Agenda Item # 16

SUB-002935-2024

The Mobile Commerce Park Subdivision,
Resubdivision of Lot 2 into Lots 2-A & 2-B

**THE MOBILE COMMERCE PARK SUBDIVISION,
RESUBDIVISION OF LOT 2 INTO LOTS 2-A & 2-B**

DETAIL SITE PLAN

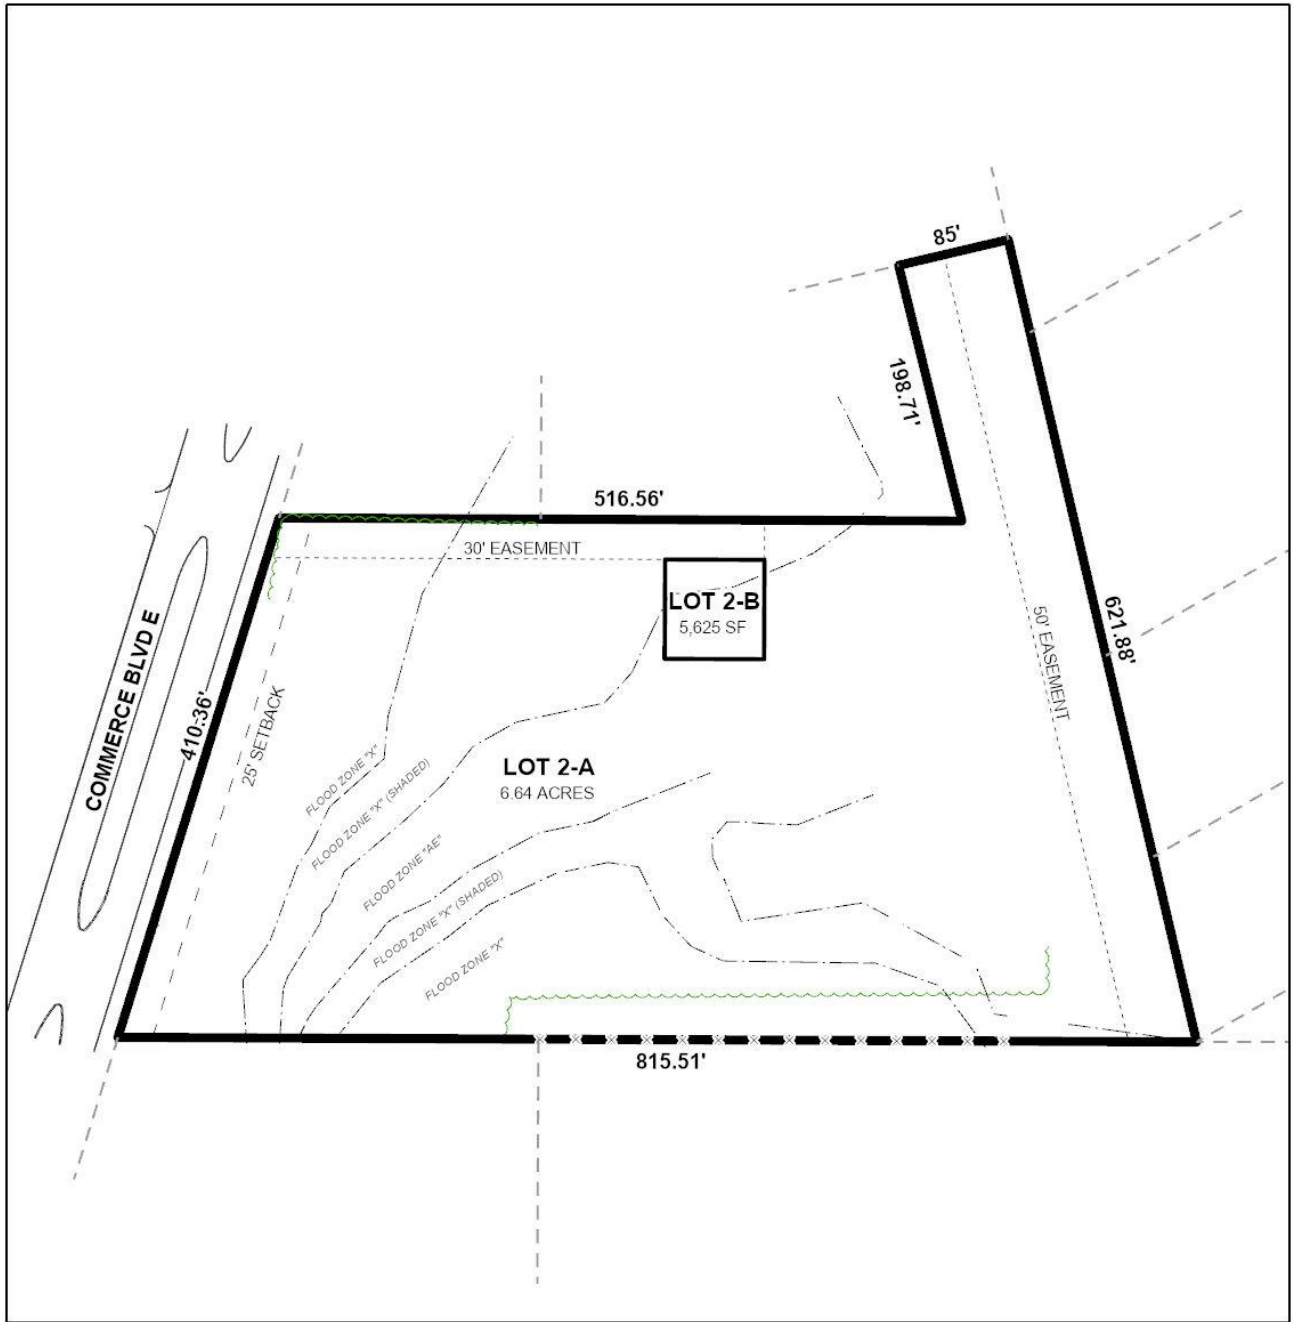
Lot 2-A of the subject site has linear frontage along Commerce Boulevard East, a minor street with curb and gutter requiring a 50-foot right-of-way. The preliminary plat does not illustrate the existing right-of-way at this location, and as such, should be revised to either label a compliant right-of-way width or illustrate dedication sufficient to provide 25 feet from the centerline of Commerce Boulevard East.

Lot 2-B of the subject site, as proposed, does not have direct frontage onto public right-of-way. The preliminary plat does, however, illustrate a 30-foot access and utility easement which grants access to the proposed lot from Commerce Boulevard East. It should be noted that Section 64-3-2.A.1. of the Unified Development Code (UDC) allows access to be provided by a recorded dedicated easement, but a waiver of Section 6.C.4. of the Subdivision Regulations will be required if approved.

A 25-foot front yard setback is illustrated along Commerce Boulevard East for Lot 2-A on the preliminary plat, in compliance with Article 2 Section 64-2-16 of the UDC for lots in B-5 districts and should be retained on the Final Plat, if approved.

The preliminary plat should be revised to depict the lot size labels in both square feet and acres on the Final Plat, or a table should be furnished on the Final Plat providing the same information.

Lot 2-A contains access, drainage and utility easements; therefore, a note should be required on the Final Plat stating that no structure may be constructed or placed within any easement without the permission of the easement holder, if approved.

1. Revision of the plat to label all abutting streets with their right-of-way widths or illustrate dedication sufficient to provide 25 feet from the centerline of Commerce Boulevard East;

2. Retention of the 25-foot front yard setback along Commerce Boulevard East;
3. Revision of the plat to include lot size labels in both square feet and acres on the Final Plat, or the furnishing of a table on the Final Plat providing the same information;

4. Placement of a note on the Final Plat stating that no structure may be constructed or placed within any easement without the permission of the easement holder;
